Draft Report from the committee to review the MINERvA Run-plan

Membership: K. Anderson, S. Brice, J. Hylan, M. Martens, C. Moore, S. Pordes (chair),
R. Zwaska

MINERVA RUN PLAN RESPONSES TO REVIEW COMMITTEE'S QUESTIONS

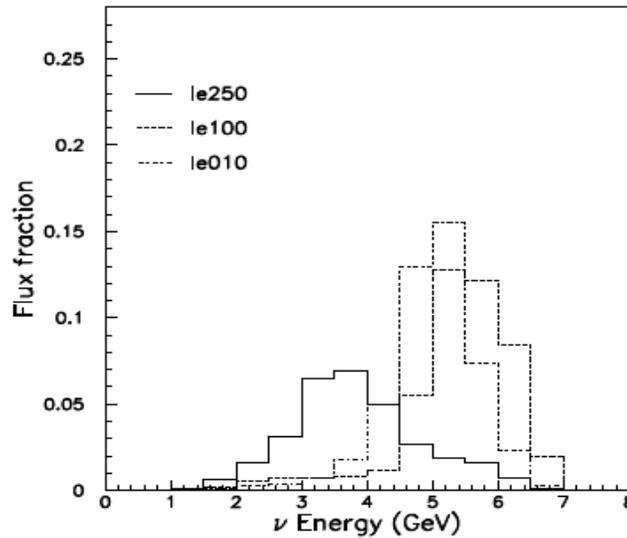
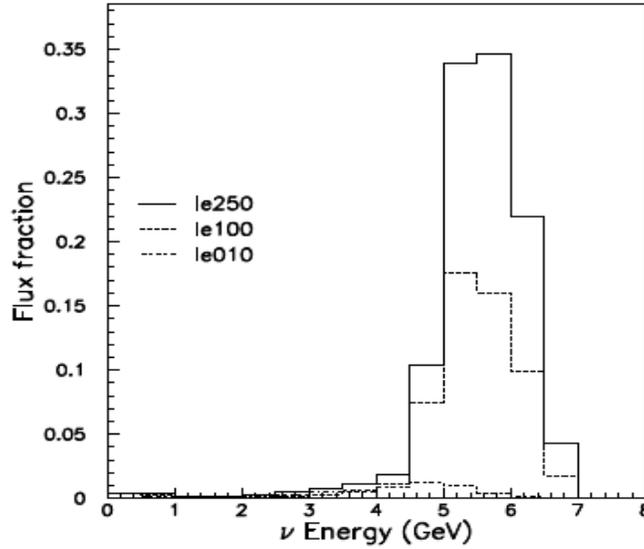
2. *Could MINERvA explain how the kinematics of the special runs work such that MINERvA can disentangle the beam flux shape as a function of pion momentum from the cross section shape as a function of $E(\nu)$.*

It is useful to see directly how the correlation between pion energy and neutrino energy is not exact. The plots below show what happens to two categories of pions, those with $p_T=(100-200)$ MeV/c (upper) and $p_T=(400-500)$ MeV/c (lower) (both have $16 < p_z < 20$ GeV/c). The vertical axis of each plot is the fraction of the neutrino flux in a given energy bin which comes from the particular bin of pion (p_T, p_z) . While the neutrino energy is related to the pion energy, the angular divergence of pions after the horns results in a rich cross-fertilization between E_ν and (p_T, p_z) . For example, in the upper plot, a value of 0.35 on the vertical axis indicates that 35% of the neutrinos of $E_\nu \sim 5.5$ GeV come from the pion bin chosen, while the remaining 65% of neutrinos at this energy would come from other pion (p_T, p_z) . The other pion bins comprising this 65% would be from those with lower p_z and p_T , or higher in p_z and p_T . Effectively, each bin of neutrino energy is derived from a diagonal stripe in the (p_T, p_z) plane). If the conjecture offered by the committee was correct, each bin in neutrino energy would be derived from a single bin in the (p_T, p_z) plane or a vertical stripe in the (p_T, p_z) plane (where p_z is along the

We therefore emphasize to the committee that the oft-held notion that pion and neutrino energy are linearly related is a *too-simplistic* view that only pertains to the the *average* pion trajectory. The actual ensemble in the beam requires kinematic (p_T, p_z) disentangling, particularly at low pion energy where focusing is never perfect. The fits to neutrino data therefore have significant power to disentangle the pion flux in the (p_T, p_z) plane.

The plots show the fraction of the neutrino flux at a given neutrino energy which is derived from two particular bins in the plane of pion (p_T, p_z) . The upper plot shows the flux arising from those with $p_T=(100-200)$ MeV/ c and the lower plot shows the flux arising from pions with $p_T=(400-500)$ MeV/ c . The range $16 < p_z < 20$ GeV/ c is selected for both plots. The vertical axis of each plot is the fraction of the neutrino flux in a given energy bin which comes from the particular bin of pion (p_T, p_z) .

MINERvA QE Statistical Errors
(LE beam $1E19$ POT, Q^2 between 0.2-0.9 GeV^2)

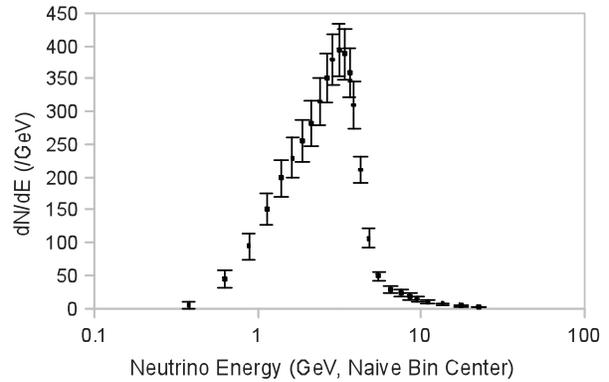
3. *Could MINERvA explain how 'standard candle cross sections' work over the whole energy range. Does this procedure in fact work over the whole energy range, and how would MINERvA be able to, for example, resolve the apparent MiniBooNE/NOMAD disagreement on the Quasi-Elastic cross section?*

measured have been studied extensively in MINERvA. Statistical uncertainties, even for a relatively small number of protons on target, will be good as shown at right.

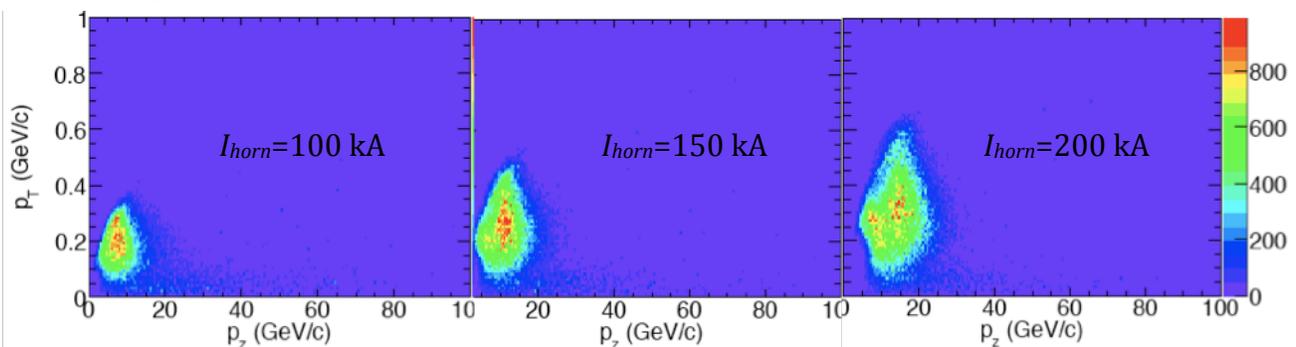
5. Please make a distinction of what information is gained in the ME vs LE special runs. Can MINERvA get by in the ME case with just horn current variations? How much is the impact?

First, there are other beam flux uncertainties besides hadron production, and these special runs allow us to limit these uncertainties. As shown on page 34 of our presentation, there are a series of effects such as the alignment of the horns and target, the current in the horn, the modeling of magnetic field in the horn material, etc, whose uncertainties tend to pile up at the edge of the focusing peak. Such focusing errors will move along with the location of the focusing peak, but have calculable relative magnitudes at each beam configuration. By performing these special runs, we are able to limit these uncertainties from their current 10% (15-20% in the ME beam) to less than 5%. We will have an entirely new beam line in the ME era, and without these runs we will have to accept a substantially larger $\sim 15\%$ flux error at ~ 10 GeV in the ME beam.

Second, horn current alone is *not a sufficient knob* to determine the hadron flux off the target. The figures below show the (p_T, p_z) sampled for $z_{target}=100$ cm, for $I_{horn}=100, 150,$ and 200 kA. As can be seen, the distribution changes inappreciably in the p_z direction, so this is largely equivalent to asking us to not take any special runs at all, and just take our event rate in the standard candle process and divide by the standard candle cross section.

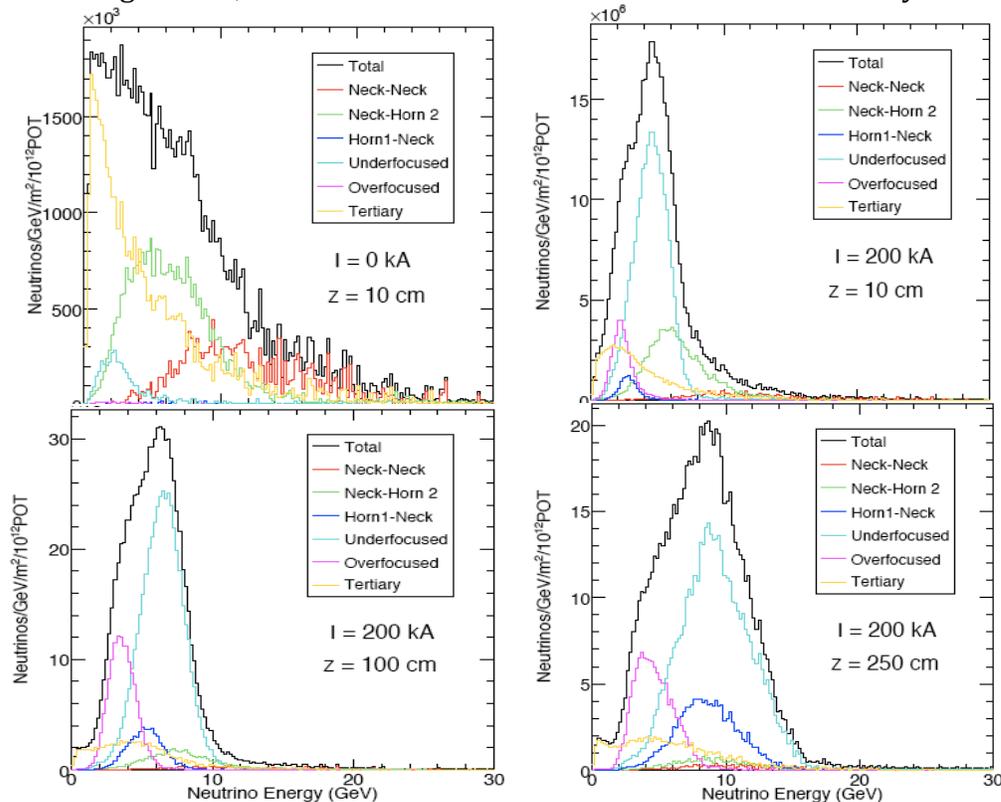
6. What is the level of tertiary production in the ME beam? Does this motivate the ME special runs?

The level of tertiary production in the ME configuration is indeed higher. The plots below show some of the horn current and target positions for the ME horn configurations. Note that tertiary production is nearly 100% of the neutrino flux in some energy bins, and even in the focusing peak during Nova running ($z=100$ cm), tertiary production is $\sim 20\%$ of the flux. The plots below show the breakdown of the various pion trajectories through the focusing, including tertiaries, in four configurations for the ME horn setting. The $(z_{target}, I_{horn})=(100$ cm, 200 kA) graph corresponds to standard running for NOvA.

Our presentation highlighted this issue as one of the reasons that MINERvA wants to perform the special test runs again in the ME configuration (it's not the only reason, see Question 5). In analyzing this ME data, MINERvA will have to include tertiaries as yet another component of the fit, accommodating the possibility that hadron production off of Aluminum (horns+windows) or Iron (decay volume) might differ from graphite (target). We have not done this analysis, and it is impossible/unreasonable to do so without the data in hand. Any mock/fake data study will be trivially successful because we will put in some model and fit it back.
